Response to SDAA Audit Question

Question Number: A-11.4-5

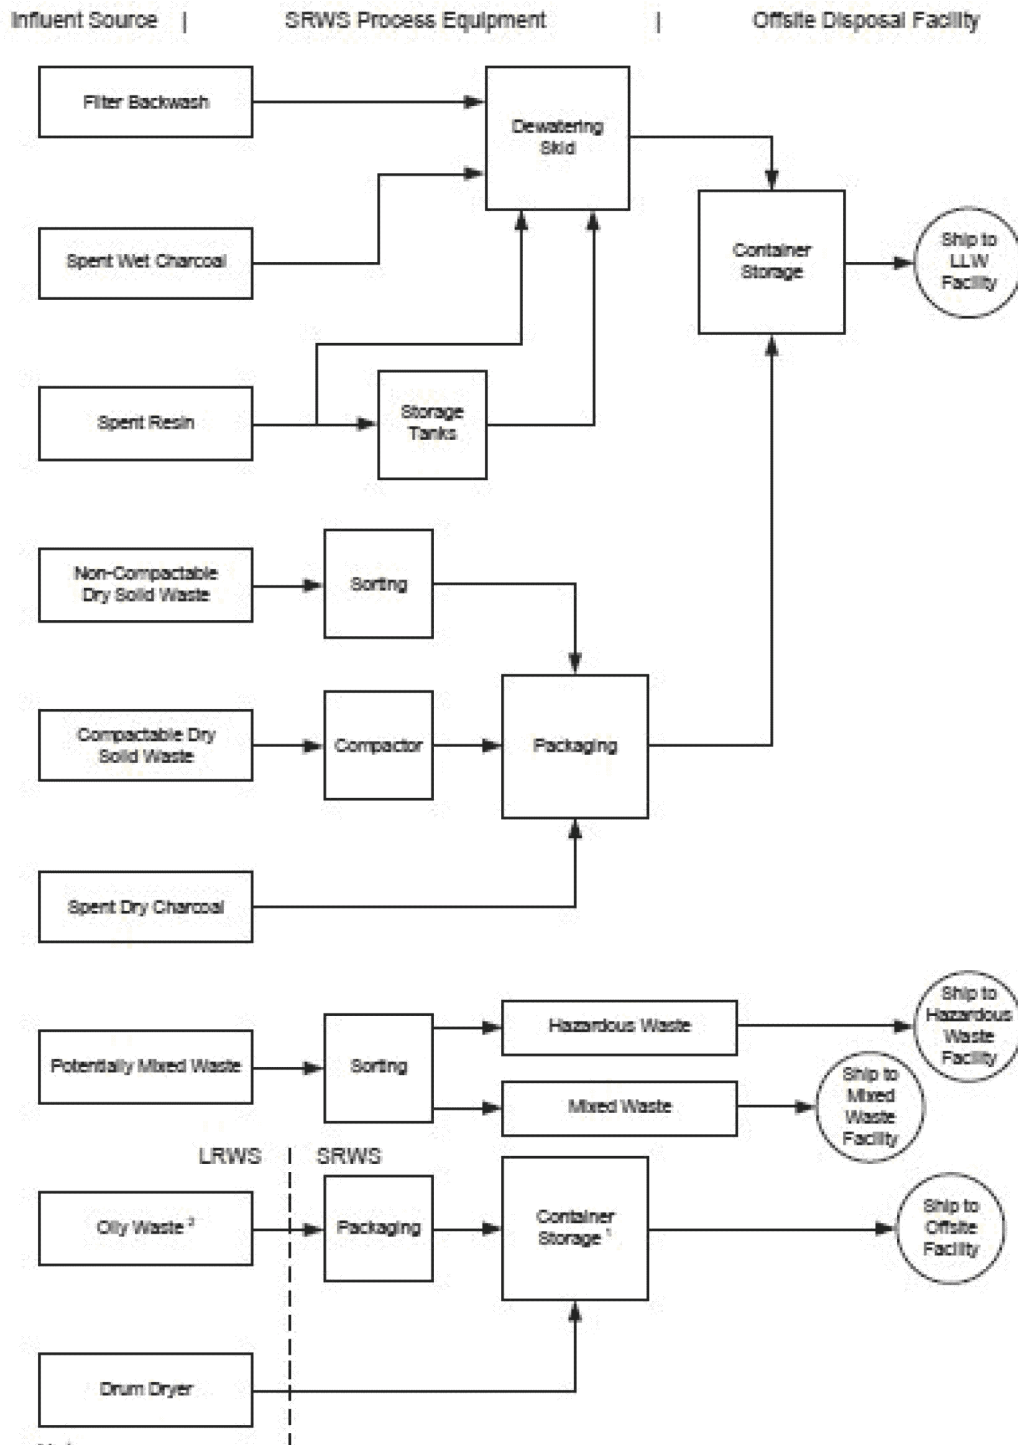
In Figure 11.4-1 there are two notes associated with the picture but they don't clearly speak to a box in the diagram. The notes should reference the boxes in the actual drawing or else it is not clear to what box the note applies? Is the drum dryer skid the same as the dewatering skid or part of the dewatering skid? Please update Figure 11.4-1 or otherwise clarify the footnotes.

The drum dryer skid and the dewatering skid are separate pieces of equipment in separate systems. The dewatering subsystem is a skid-based, vendor-supplied package that removes free-standing water from waste packages to meet transportation and disposal requirements. The dewatering subsystem is a part of the solid radioactive waste system. The drum dryer skid is used to concentrate filtration reject and detergent waste. The drum dryer skid is part of the liquid radioactive waste system. NuScale is updating Figure 11.4-1 as shown below to clarify the footnotes.

- 1) The Drum Dryer skid is part of the LRWS. Filled, 55-gallon drums are transferred to the SRWS for storage ("Container Storage") and eventual disposal.
- 2) Oily waste is part of the LRWS. Oily waste influent from the LRWS is packaged in 55-gallon drums in the LRWS and then shipped offsite.
